**RE: TREE PROTECTION PLAN FOR 2040 ARROWSMITH DRIVE, OTTAWA**

This tree protection plan was prepared by IFS Associates Inc. (IFS Inc.) in support of a building permit for 2040 Arrowsmith Drive in Ottawa. The need for this report is related to trees protected under the City of Ottawa's Tree Protection By-law (By-law No. 2020-340). The work proposed includes demolishing existing buildings and construction of a six-storey mixed-use building (see plan on page 7 of this report). A driveway with retaining wall and curb is proposed for the rear of the building and is adjacent to a stand of trees on the neighbouring property at 2000 Jasmine Crescent. This plan details efforts to ensure the successful retention of these trees.

### RESPONSES TO CITY COMMENTS

DRAWING: Tree Protection Plan

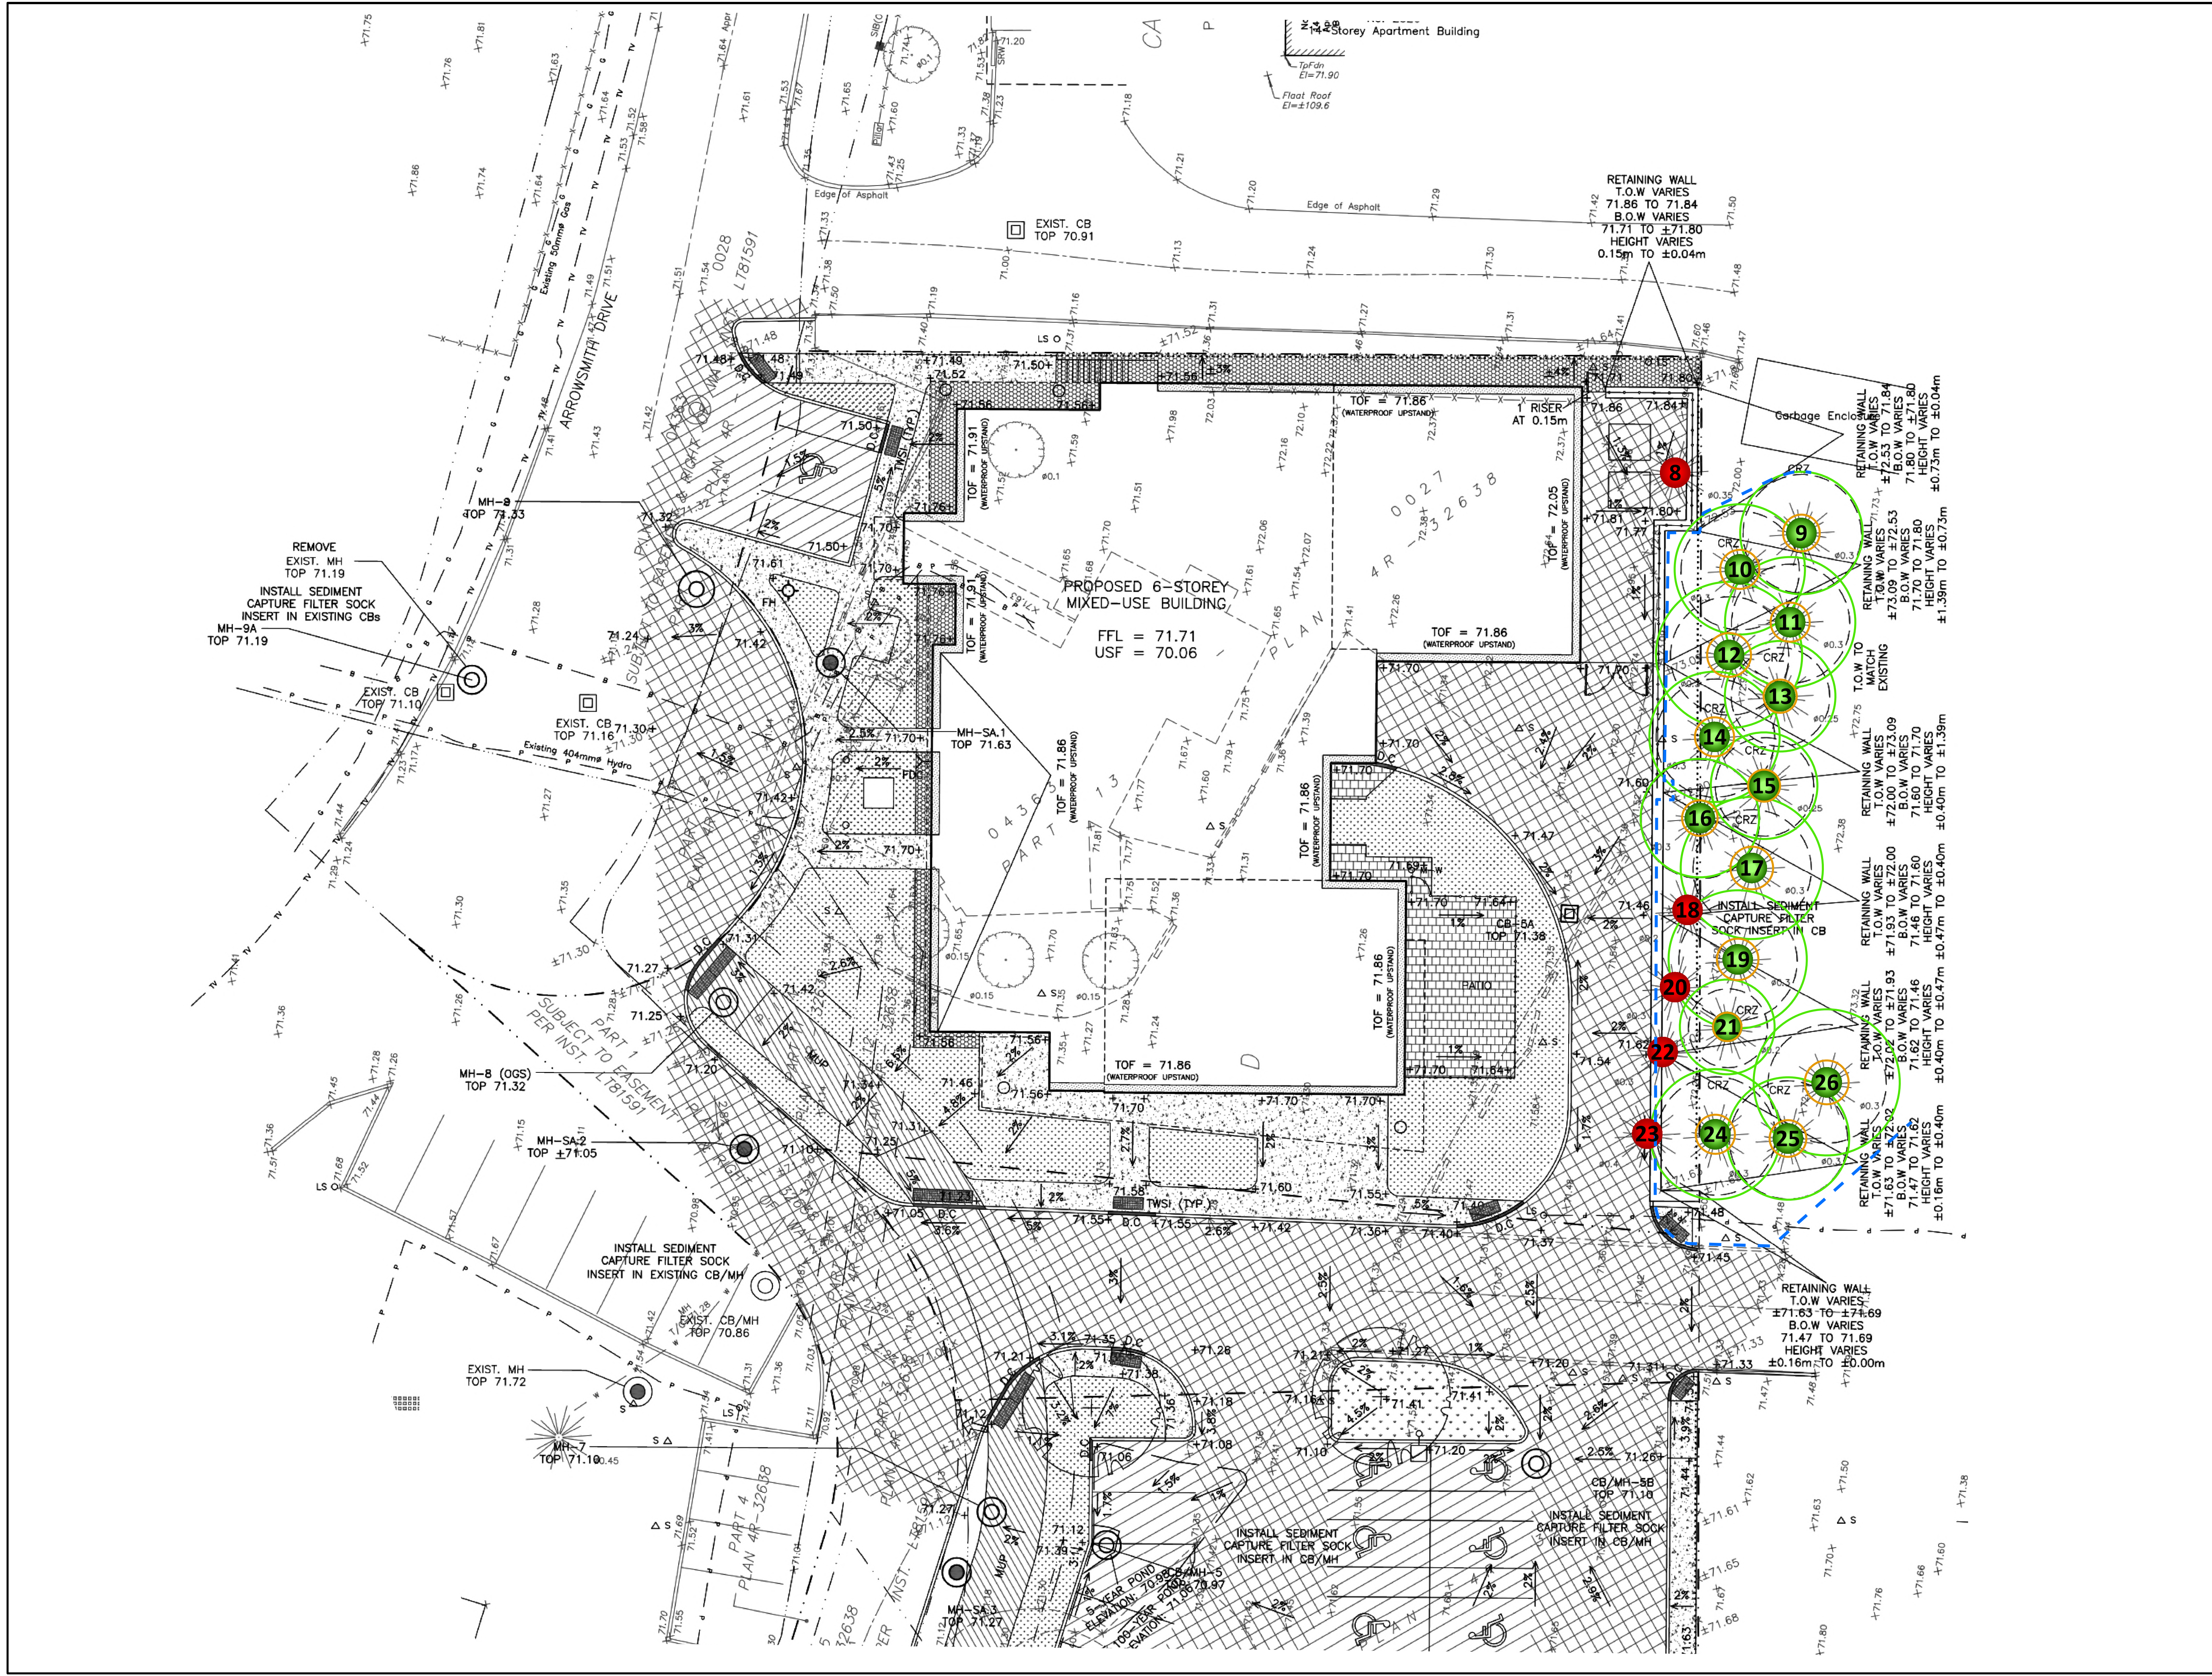
1b) *What extent of impact to the CRZs of these retained trees will occur and will it cause retained tree health to decline? Will there be excavation within the static root zone of the tree (Diameter x 3)?*

1g) *The consulting engineer and RPF must discuss the grade changes proposed along the eastern edge of the site. The trees are growing on a berm. A retaining wall, curb and access road will be installed along the edge of this growing space. Identify the implications of this work in the plan.*

At most, 30% of one tree’s CRZ (tree #16) will be impacted by grading. This equals the maximum recommended in ISA best management practices. As shown in the plan on page 7, no static root zones will be impacted.

The consulting engineer and forester have discussed the implications of the work proposed along the eastern edge of the site. Grading behind the proposed retaining wall remains as existing. Approximately 30% of the CRZ of tree #16 will be impacted while lesser amounts of the CRZs of trees #10, 12, 14 and 24 will be impacted.
